GROUP	MODEL
Product Improvement	2024-2026MY EV9 (MV1, MV1a)
NUMBER	DATE
PI2601A	April 2026

TECHNICAL SERVICE BULLETIN

SUBJECT: **PASSENGER SIDE WIPER ARM REPLACEMENT (PI2601A)**

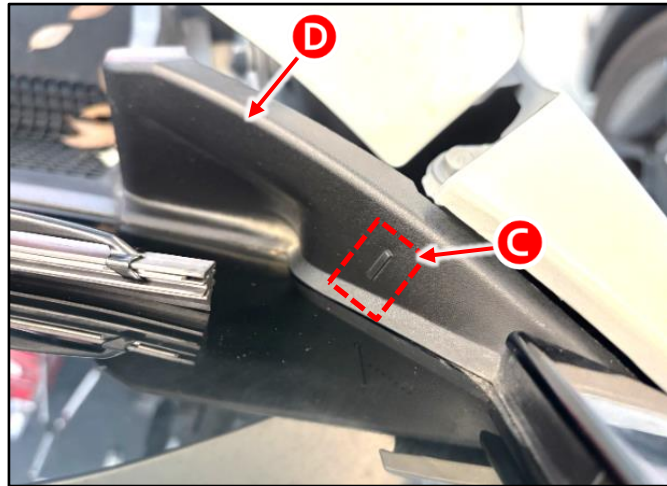
1. Remove the passenger-side (RH) windshield wiper arm (A) by referring to "Body (Interior / Exterior / Electrical) → Exterior Green House → Wiper Arm → Removal and Installation" in the applicable Shop Manual on KGIS.

Tightening torque for nut (B):
6.5 - 9.4 lb.ft (8.8 - 12.7 N.m)

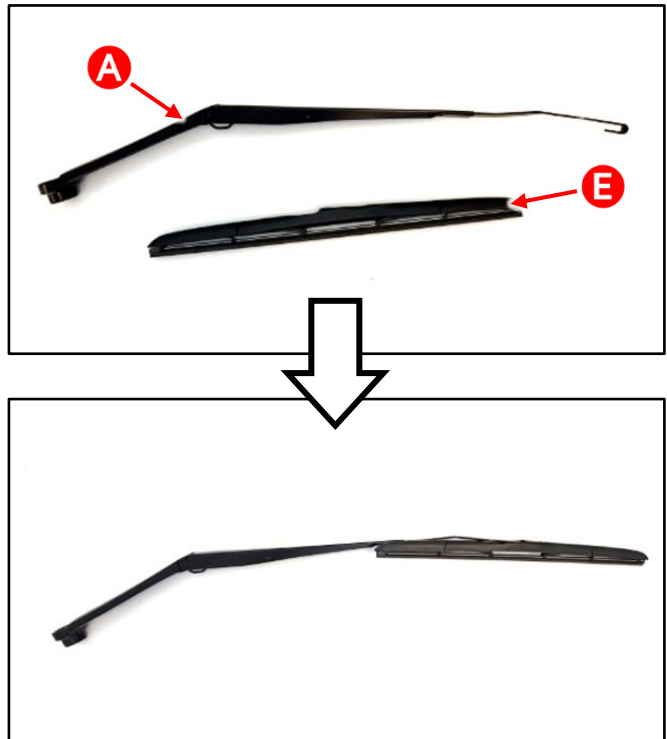
2. Locate the installation mark (C) stamped on the passenger (RH) A pillar garnish (D).

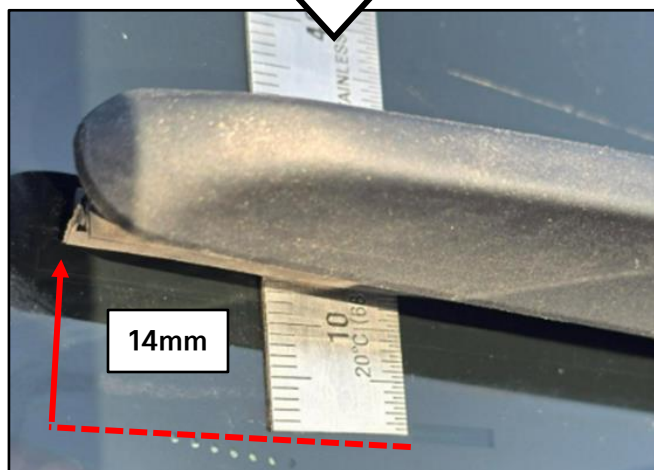
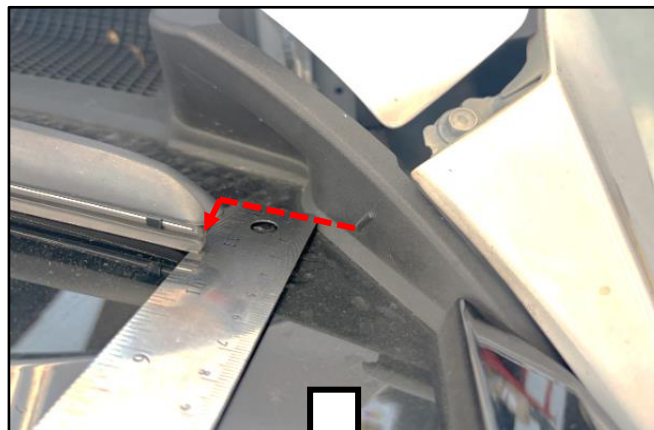
- 4a. Install the **new** wiper arm (A) and wiper blade (E) but **DO NOT INSTALL THE NUT (B)**.
- 4b. Align the tip of the wiper blade (E) rubber 14 mm **HIGHER** than the existing installation mark.

The wiper arm **MUST** be installed at the specified height.

- 5a. Install the nut (B).
- 5b. Apply light downward pressure on the wiper arm (A) at the spring when tightening nut (B). This prevents the wiper arm from popping up, which could cause interference between the wiper arm and the hood.
6. Reinstall all removed parts in reverse order or removal.
7. Confirm normal wiper operation.
